UNITED STATES  
DEPARTMENT OF THE INTERIOR  
BUREAU OF LAND MANAGEMENT

FORM APPROVED  
OMB NO 1004-0135  
Expires: July 31, 2010**SUNDRY NOTICES AND REPORTS ON WELLS**  
**Do not use this form for proposals to drill or to re-enter an abandoned well. Use form 3160-3 (APD) for such proposals.****SUBMIT IN TRIPLICATE - Other instructions on reverse side.**

API Number 30-015-39551	Pool Code 28509	Pool Name Grayburg Jackson;SR-Q-Grbg-SA
Property Code 308086	Property Name BURCH KEELY UNIT	Well Number 699
GRID No. 229137	Operator Name COG OPERATING, LLC	Elevation 3602'

OPERATOR'S NAME:	COG Operating
LEASE NO.:	LC028784C
WELL NAME & NO.:	Burch Keely Unit 699
SURFACE HOLE FOOTAGE:	0890' FNL & 0330' FEL
BOTTOM HOLE FOOTAGE	
LOCATION:	Section 25, T.17S., R.29 E., NMPM
COUNTY:	Eddy County, New Mexico

WELL LOCATION AND ACREAGE DEDICATION PLAT

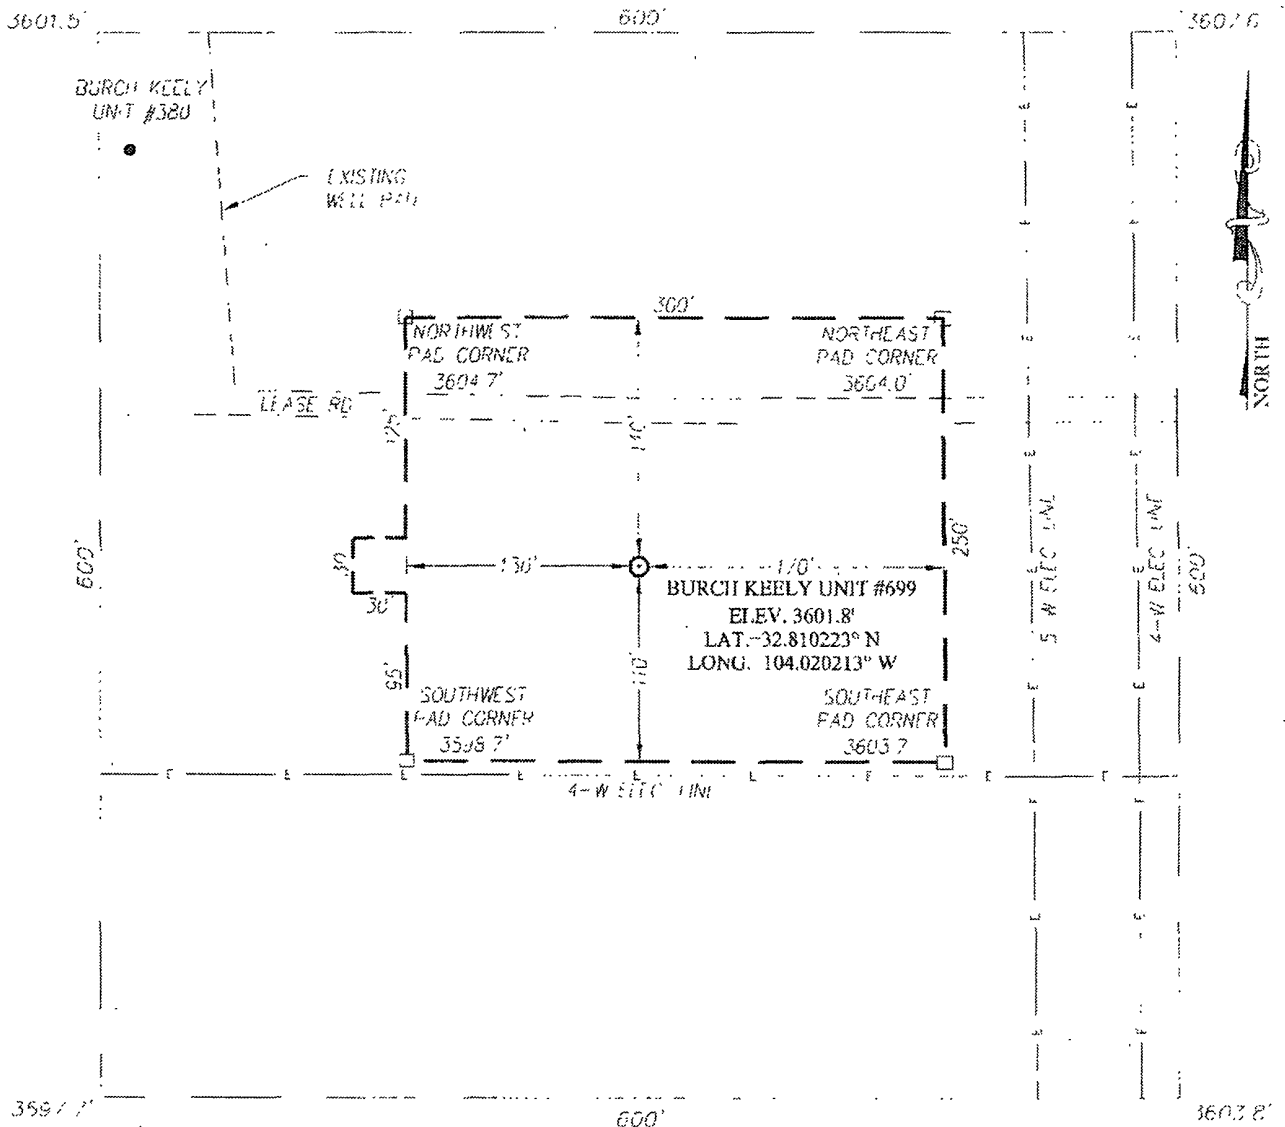
COG Operating respectfully requests permission to change the location of this well to:

890'FNL &amp; 330'FEL, Sec 25, T17S, R29E, Unit A

Reason for change of location is due to a change in the Plan of Development.
